Work Order ID 126869

Item ID: D4680-041

Item Name: Skidtube Assembly

E/D per ECN 15-551 UMC 15-6-25

DRAWING NO.	REV. C
D4680	SHEET 2 OF 3
TITLE	SCALE
SKIDTUBE	NTS

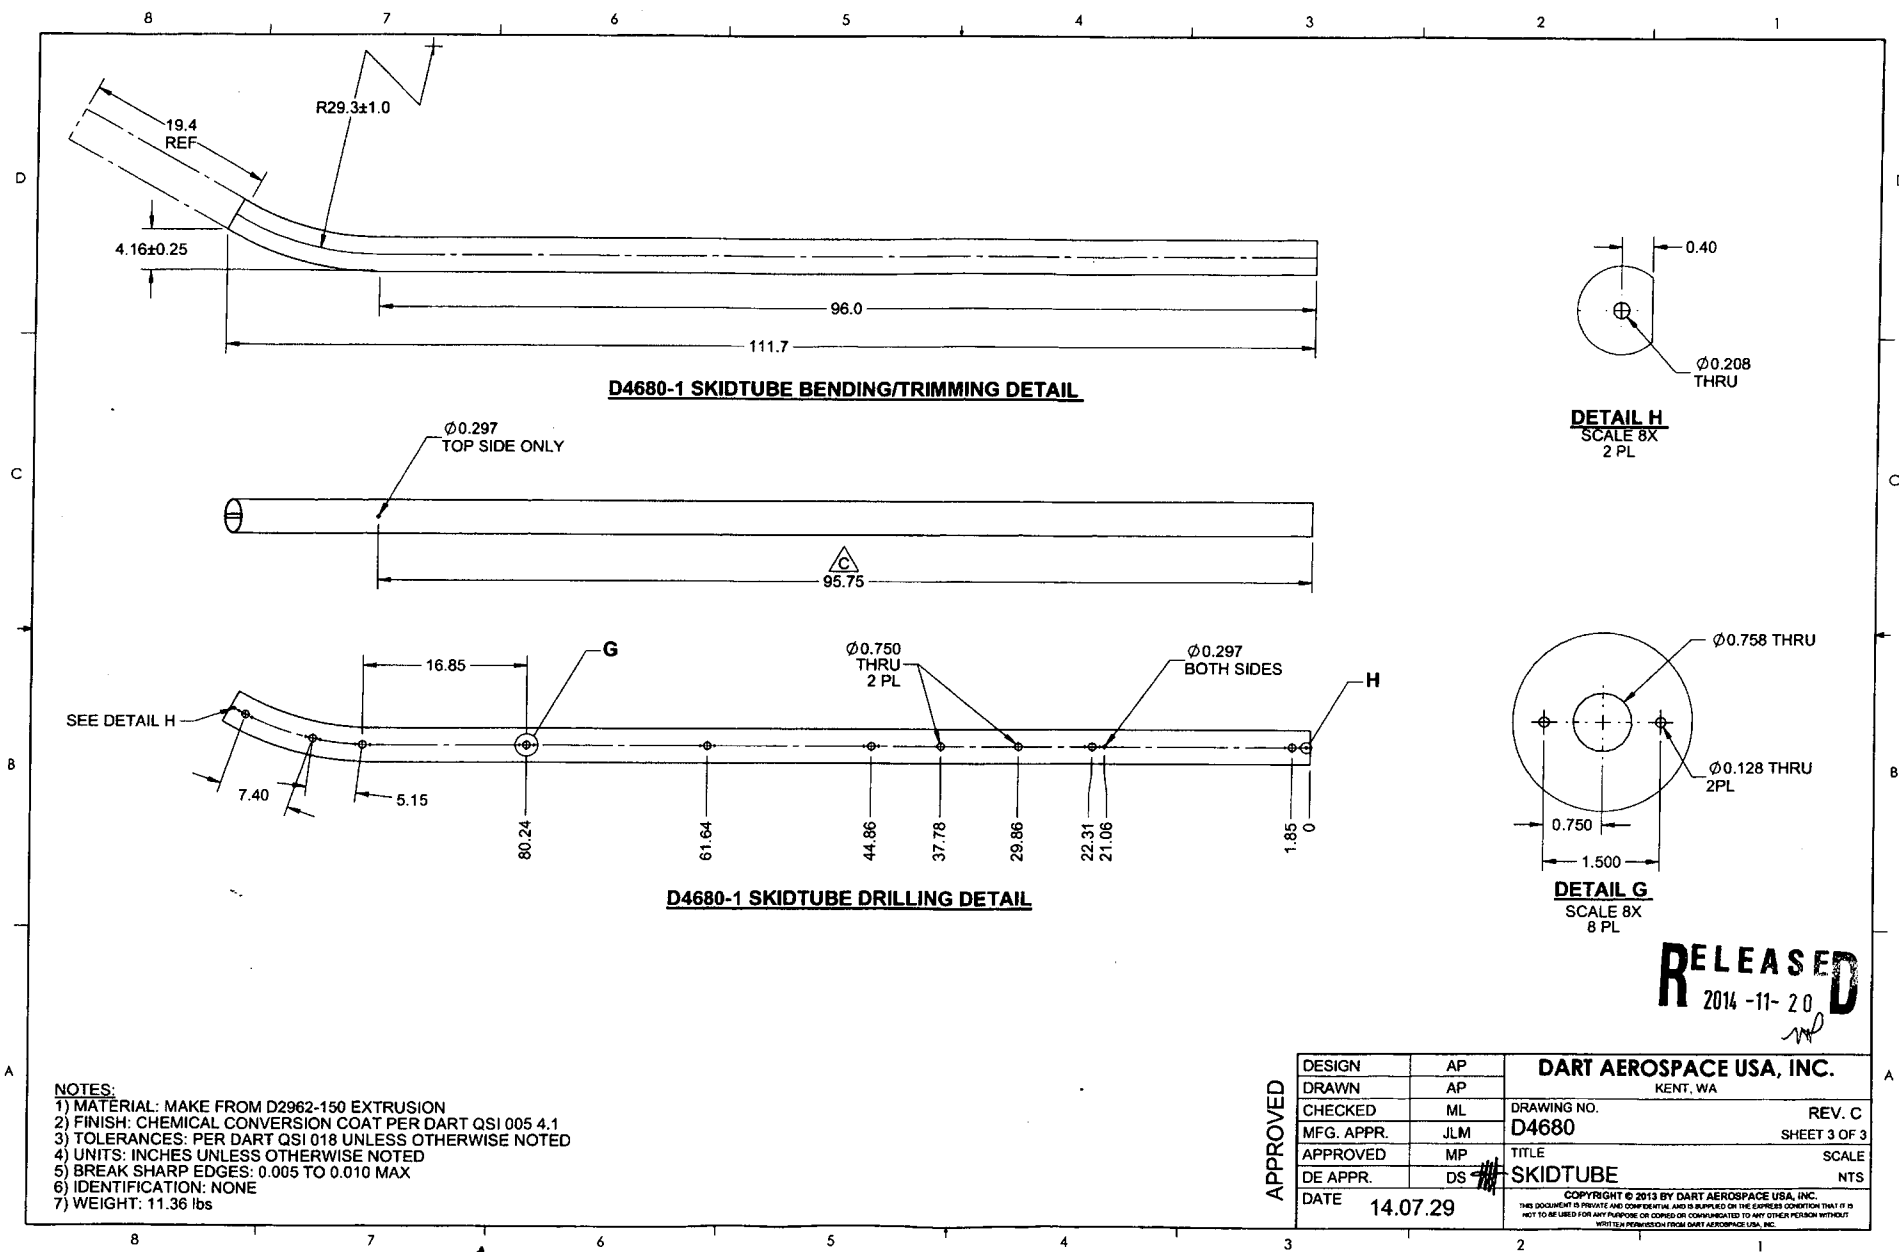
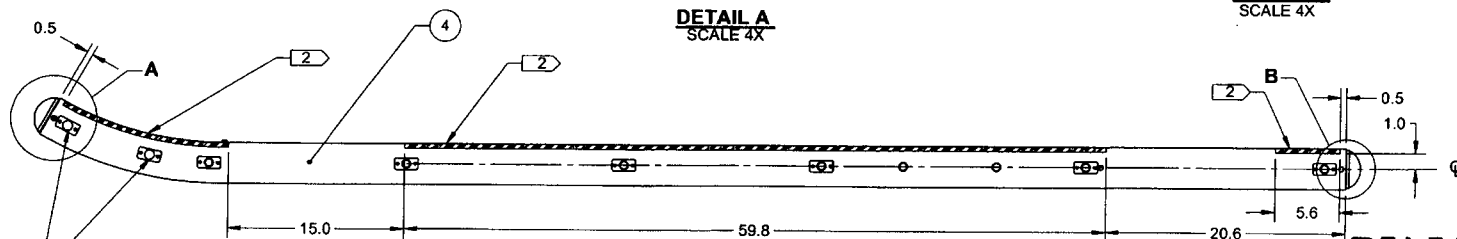
C	NAS1149F0332P WAS AN960-10L, AN526C1032R10 WAS AN526C1032-10, FWD GROUNDING STRAP FASTENER MOVED AFT (C5-3), Ø0.750 WAS Ø0.758 (B4-3).	AP	14.07.29
B	FWD CAP WAS D2965 NOW D2965-3, VARIOUS DIMENSIONAL CHANGES D3492-055 PLUG ASSY WAS D3492-051, SWAGING DIMENSION NOW 0.650 WAS 0.661 (D6-2), ADDED DETAIL H (C2-3), MATERIAL D2962-150 WAS D2962-131 (A7-3), GROUND HANDLING THRU HOLES NOW WELDED, ADDED SECTION G-G (D3-2)	AP	13.09.10
A	NEW ISSUE	AP	13.02.13
REV.	DESCRIPTION	BY	DATE
DESIGN	AP	DART AEROSPACE USA, INC. KENT, WA DRAWING NO. D4680 TITLE SKIDTUBE SCALE NTS COPYRIGHT © 2013 BY DART AEROSPACE USA, INC. THIS DOCUMENT IS PRIVATE AND CONFIDENTIAL AND IS SUPPLIED ON THE EXPRESS CONDITION THAT IT IS NOT TO BE USED FOR ANY PURPOSE OR COMMUNICATED TO ANY OTHER PERSON WITHOUT WRITTEN PERMISSION FROM DART AEROSPACE USA, INC.	
DRAWN	AP		
CHECKED	ML		
MFG. APPR.	JLM		
APPROVED	MP		
DE APPR.	DS		
DATE	14.07.29	REV. C SHEET 1 OF 3

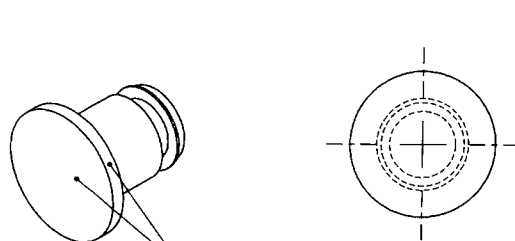
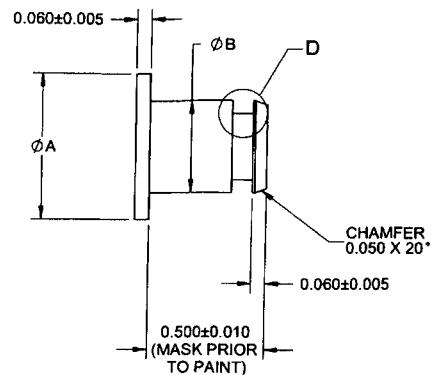
E	ADD -055 PLUG ASSY & -15 PLUG	AP	13.08.08
D	INCORPORATED DEO D3492-C-1. SHT 2 DIM C FOR -1 WAS 0.055. (SEE CAR11-048)	AJS	11.05.24
C	ADD -049/-051/-053. CHANGE DRAWING FORMAT	PH	07.10.05
B	ADD -047: UPDATE DIM A FOR -045	PH	06.05.11
A	NEW ISSUE	PH	06.01.04
REV.	DESCRIPTION	BY	DATE
DESIGN	PH	DART AEROSPACE LTD HAWKESBURY, ONTARIO, CANADA	
DRAWN	AP		
CHECKED	AJS	DRAWING NO.	REV. E
MFG. APPR.	14	D3492	SHEET 1 OF 2
APPROVED	14	TITLE	SCALE
DE APPR.	14	PLUG	NTS
DATE	13.08.08	COPYRIGHT © 2007 BY DART AEROSPACE LTD THIS DOCUMENT IS PRIVATE AND CONFIDENTIAL AND IS SUPPLIED ON THE EXPRESSED CONDITION THAT IT IS NOT TO BE USED FOR ANY PURPOSE OR COMMUNICATED TO ANY OTHER PERSON WITHOUT WRITTEN PERMISSION FROM DART AEROSPACE LTD.

DRAWING NO.	REV. D
D4680	SHEET 2 OF 3
TITLE	SCALE
SKIDTUBE	NTS

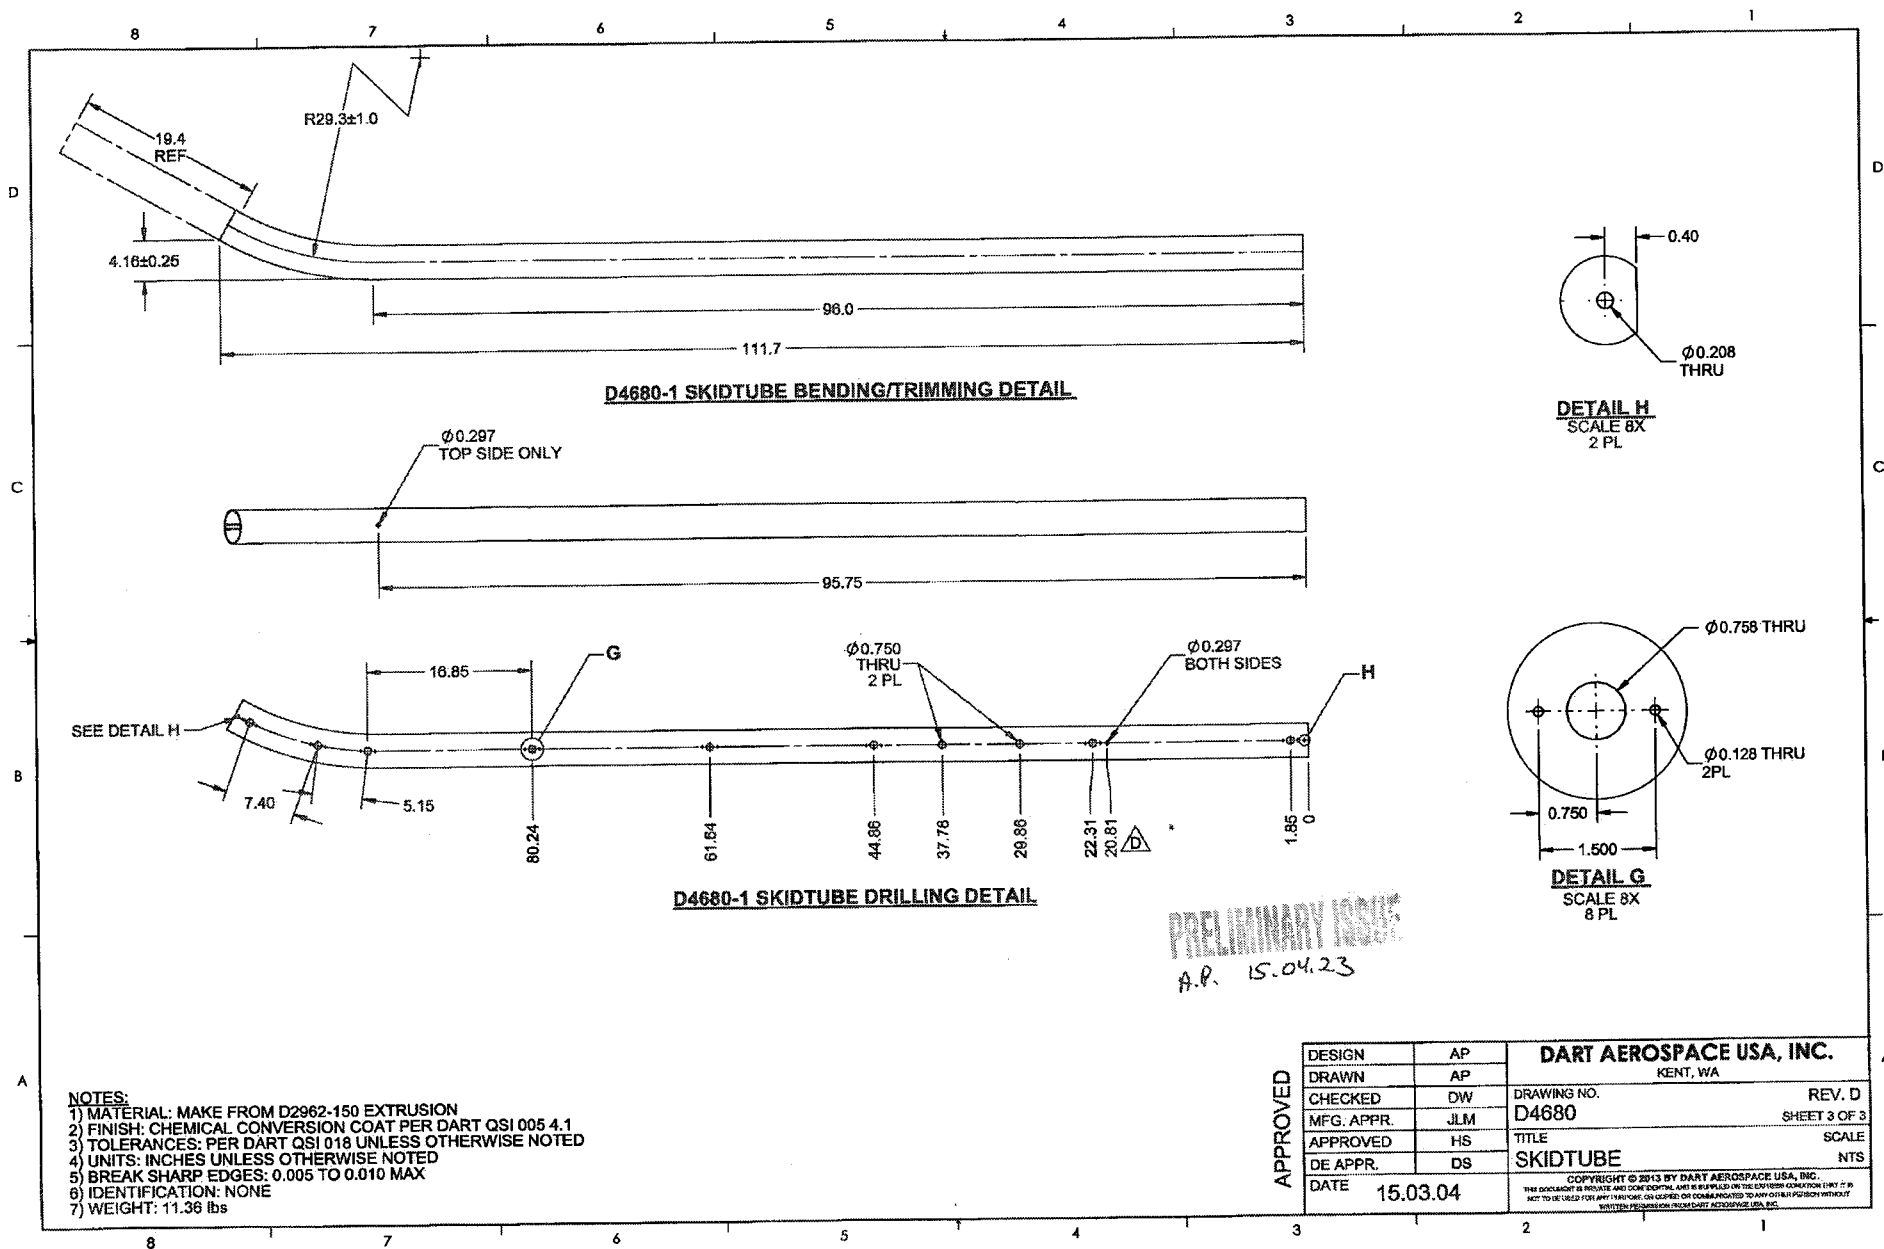
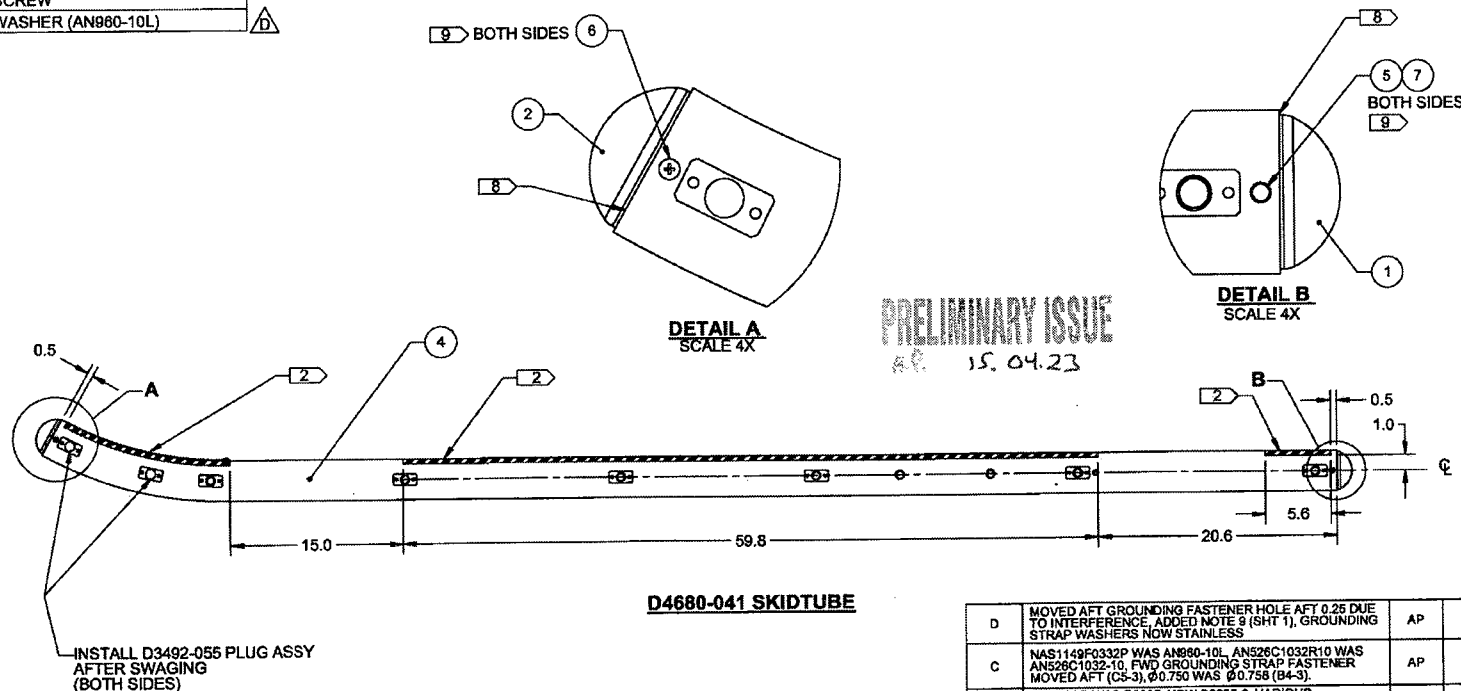
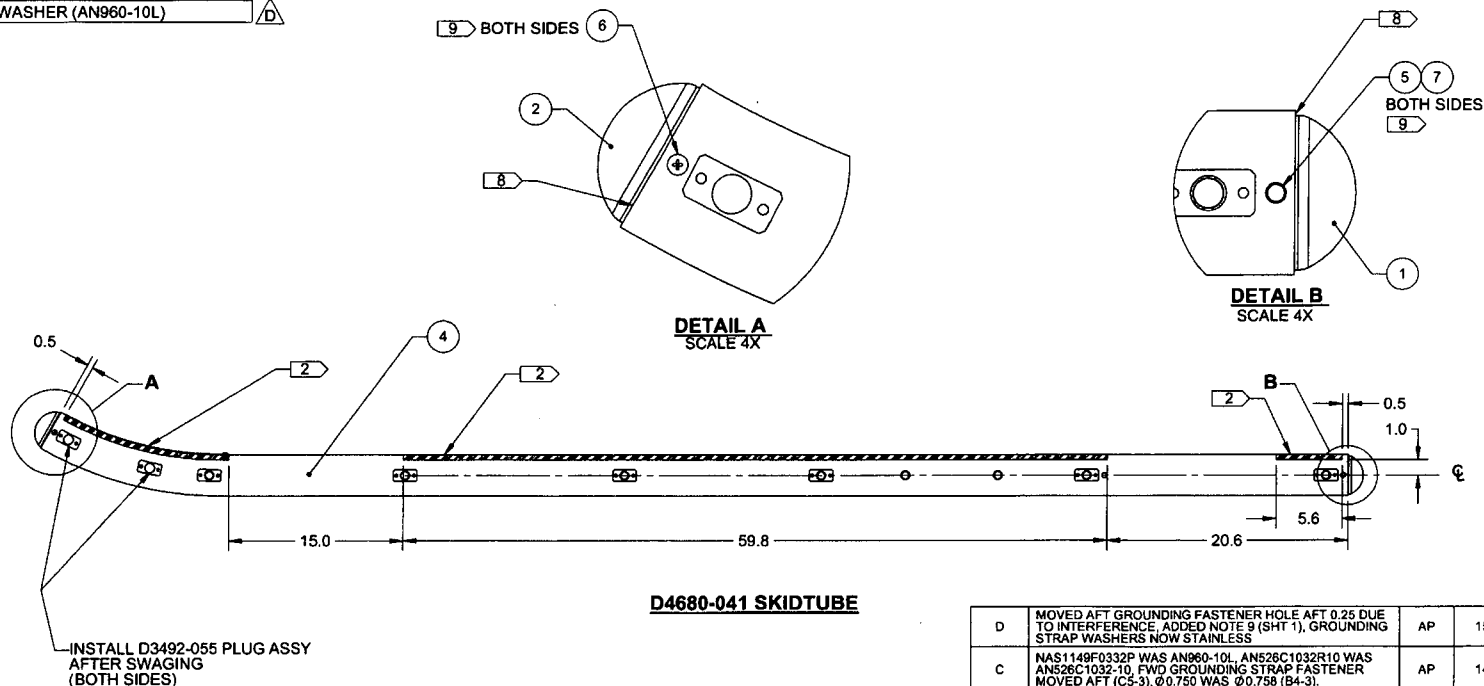
D	MOVED AFT GROUNDING FASTENER HOLE AFT 0.25 DUE TO INTERFERENCE. ADDED NOTE 9 (SHT 1), GROUNDING STRAP WASHERS NOW STAINLESS	AP	15.03.04
C	NAS1149C0332P WAS AN960-10L, AN526C1032R10 WAS AN526C1032-10, FWD GROUNDING STRAP FASTENER MOVED AFT (C5-3), Ø0.750 WAS Ø0.758 (B4-3).	AP	14.07.29
B	FWD CAP WAS D2965 NOW D2965-3, VARIOUS DIMENSIONAL CHANGES. D3492-055 PLUG ASSY WAS D3492-051, SWAGING DIMENSION NOW 0.650 WAS 0.661 (D6-2), ADDED DETAIL H (C2-3), MATERIAL D2862-150 WAS D2862-131 (A7-3), GROUND HANDLING THRU HOLES NOW WELDED, ADDED SECTION G-G (D3-2)	AP	13.08.10
A	NEW ISSUE	AP	13.02.13
REV.	DESCRIPTION	BY	DATE
DESIGN	AP	DART AEROSPACE USA, INC. KENT, WA	
DRAWN	AP		
CHECKED	DW		
MFG. APPR.	JLM		
APPROVED	HS		
DE APPR.	DS	TITLE SKIDTUBE	
DATE	15.03.04	SCALE NTS

D	MOVED AFT GROUNDING FASTENER HOLE AFT 0.25 DUE TO INTERFERENCE. ADDED NOTE 9 (SHT 1), GROUNDING STRAP WASHERS NOW STAINLESS	AP	15.03.04
C	NAS1149F0332P WAS AN960-10L, AN526C1032R10 WAS AN526C1032-10, FWD GROUNDING STRAP FASTENER MOVED AFT (C5-3), Ø0.750 WAS Ø0.758 (B4-3).	AP	14.07.29
B	FWD CAP WAS D2965 NOW D2965-3, VARIOUS DIMENSIONAL CHANGES. D3492-055 PLUG ASSY WAS D3492-051. SWAGING DIMENSION NOW 0.650 WAS 0.661 (D6-2). ADDED DETAIL H (C2-3). MATERIAL D2962-150 WAS D2962-131 (A7-3). GROUND HANDLING THRU HOLES NOW WELDED, ADDED SECTION G-G (D3-2)	AP	13.09.10
A	NEW ISSUE	AP	13.02.13
REV.	DESCRIPTION	BY	DATE
DESIGN	AP	DART AEROSPACE USA, INC. KENT, WA	
DRAWN	AP		
CHECKED	DW	DRAWING NO. D4680	
MFG. APPR.	JLM	REV. D	
APPROVED	HS	SHEET 1 OF 3	
DE APPR.	DS	TITLE SKIDTUBE	
DATE	15.03.04	SCALE NTS
